Change Notice

SW Series

Deletion of Factory Code on SW3006A/U Case

SW3006A/U Rocker

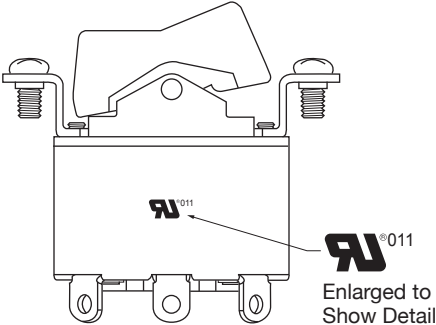
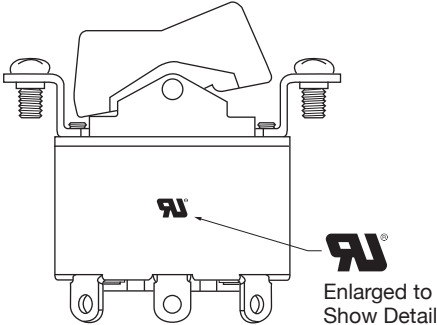
The SW Series rocker SW3006A/U will have a change to the printing on the case. Currently, the switch case has a UL marking and a factory code of 011. This will be revised to the same UL marking but without the numeric code. This change will effect both standard and custom models of SW3006A/U. The following table illustrates the differences before and after the revisions.
